DUNELAND SCHOOL CORPORATION

2020 NURSE'S OFFICE RENOVATIONS AT: BAILLY ELEMENTARY SCHOOL

TRIA PROJECT#: 20-006

ISSUED FOR PROPOSAL:
APRIL 07, 2020

1 PARTIAL FLOOR PLAN - LIGHTING - ELECTRICAL
1/4" = 1'-0"

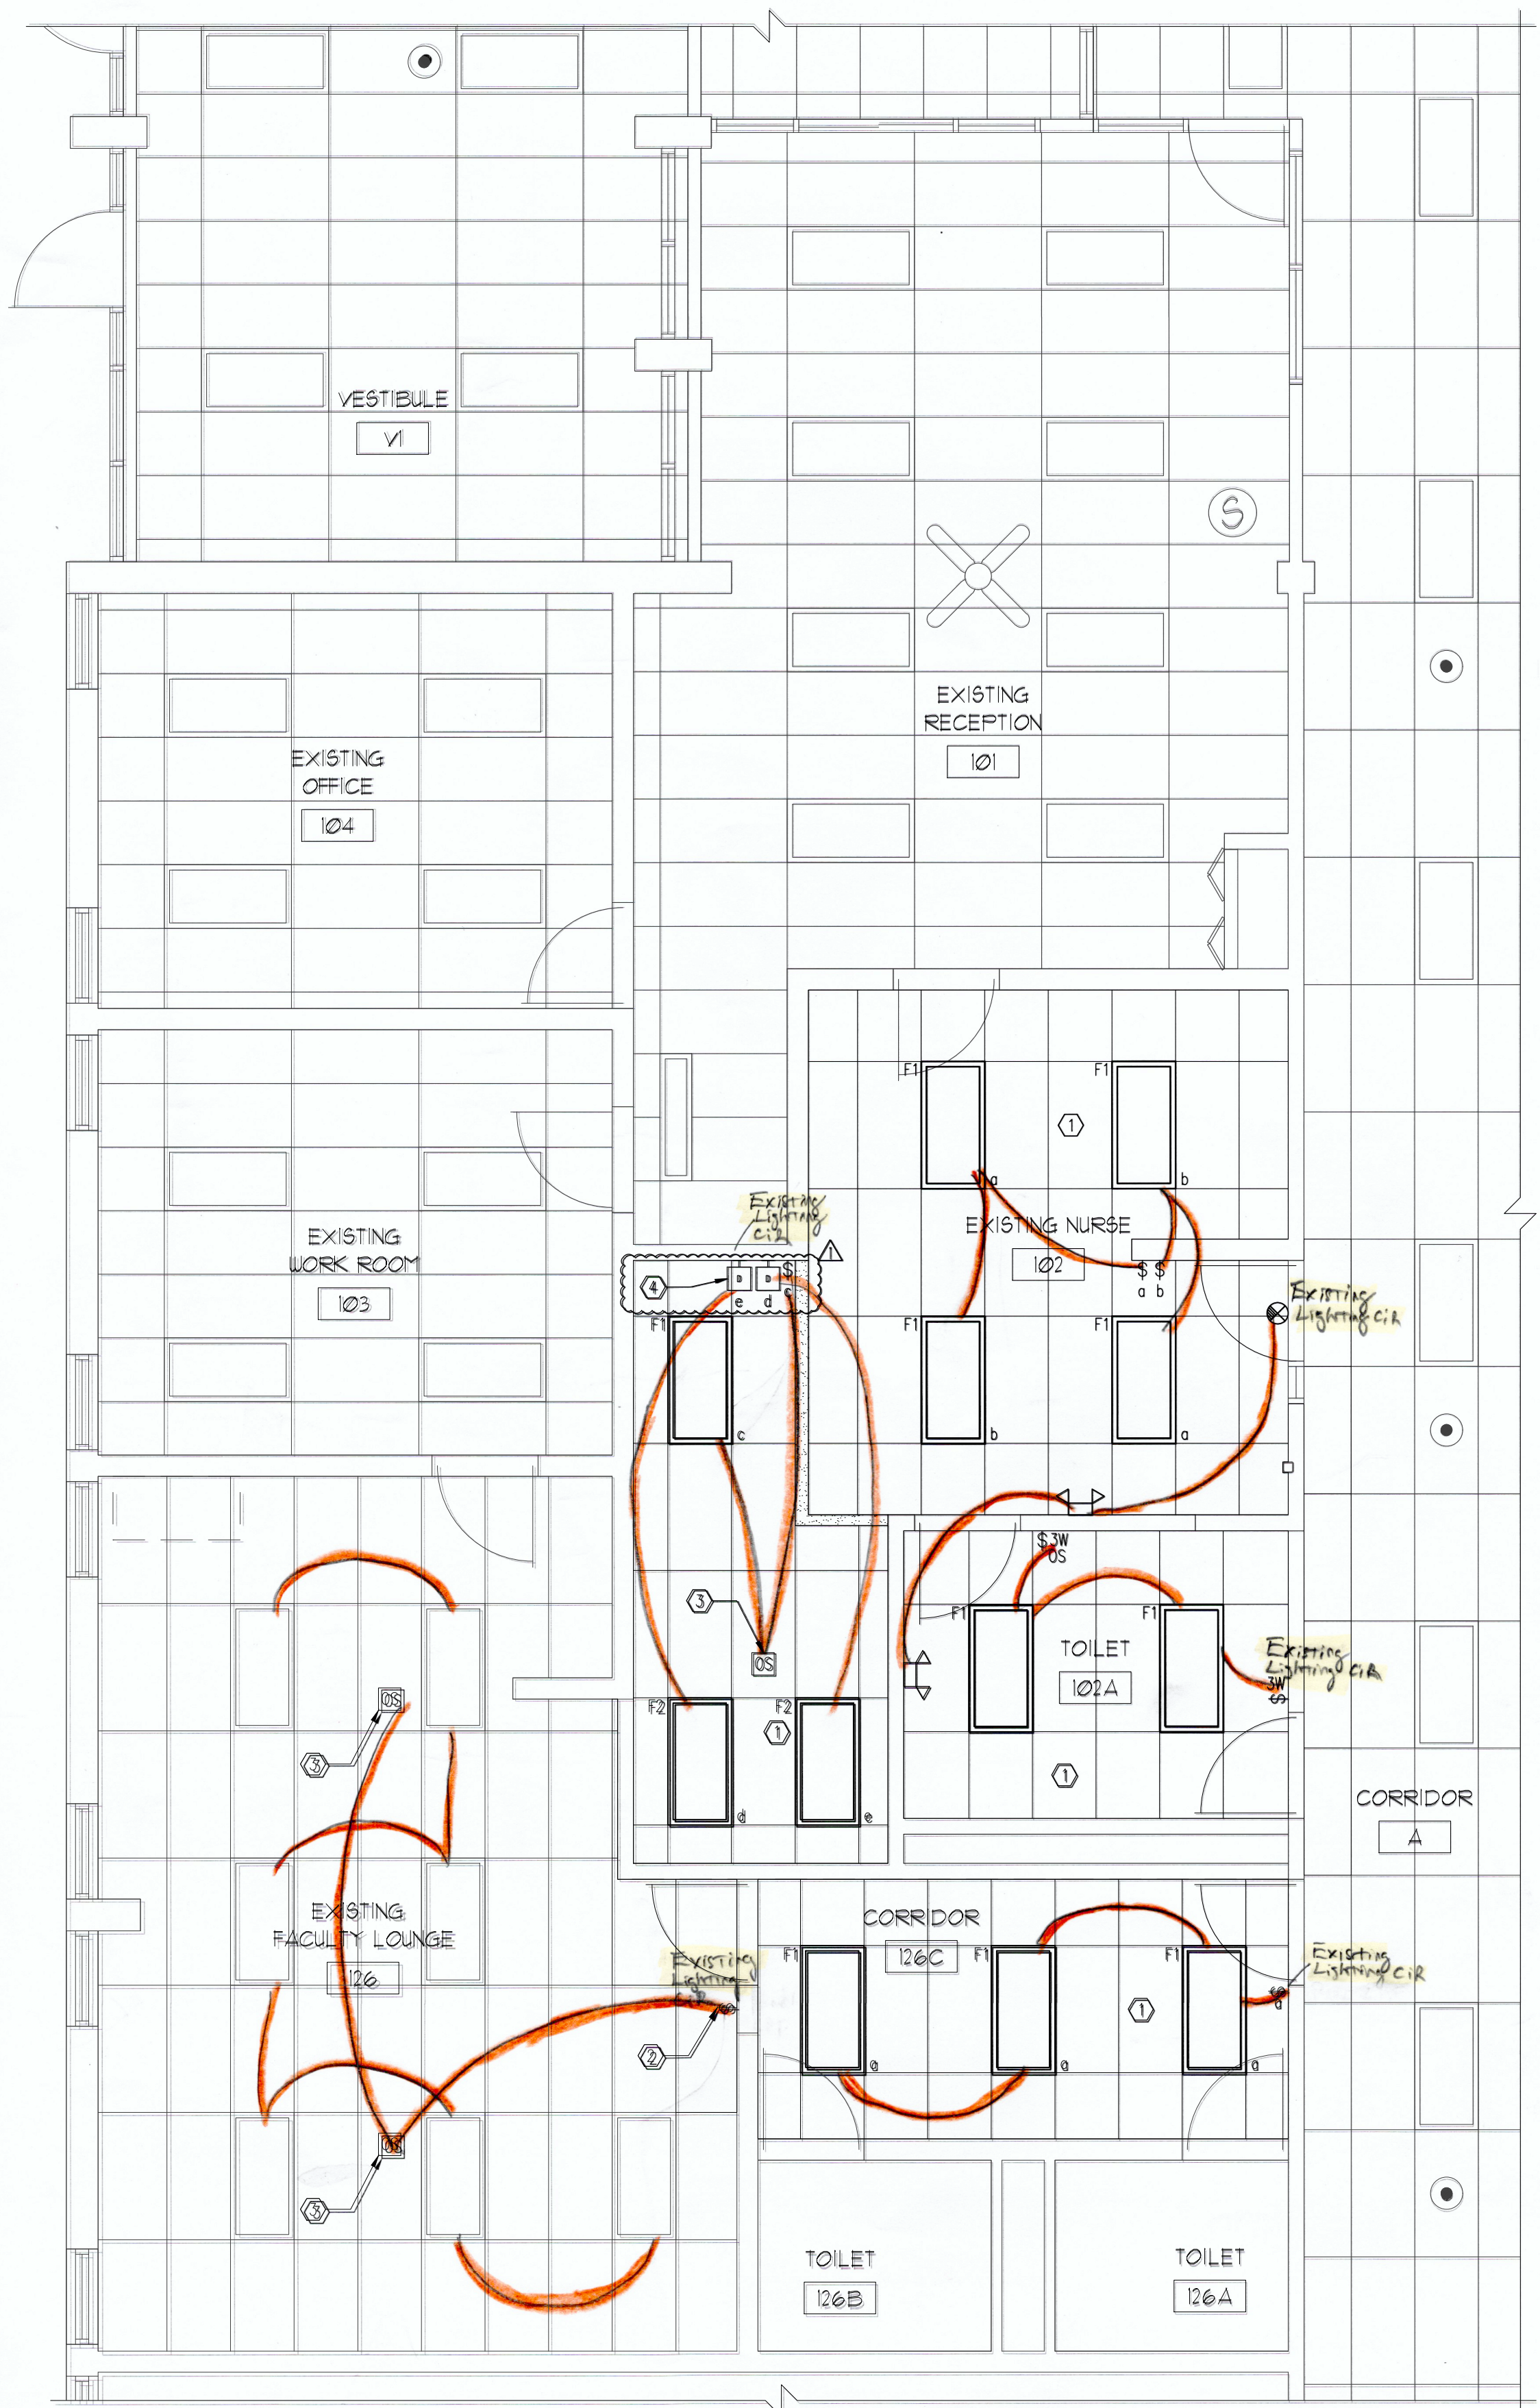
CC:
Subject: Emergency Lights

Request:
Please clarify the mounting of the emergency lights. Print show wall mount and the approved fixture is ceiling mount. Please advise whether or not we will proceed with wall mounting.
